Access Compliance Report Public Rights-of-Way (Curb Ramps)

Main Street: TIERNO_RD		Cross Street: N/A		Location:	W
ADA ID: RPRK211129125727	Ramp Type: Type 4 - Parallel	Initial Pass/Fail: Fail	Overall Compliance: No	Severity Score:	2
Codes/Mitigation Info/Possible Solution			Field Measurements/Component Compliance

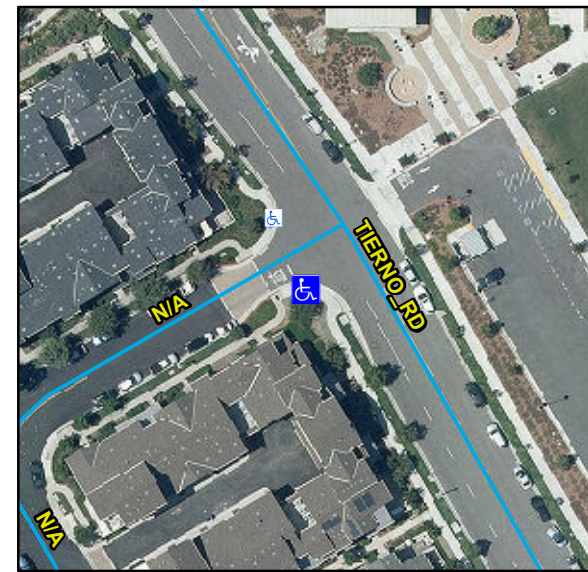
R304.5.3, STD 1115

Remove & Replace Curb Ramp With Two New Directional Ramps or Equivalent.
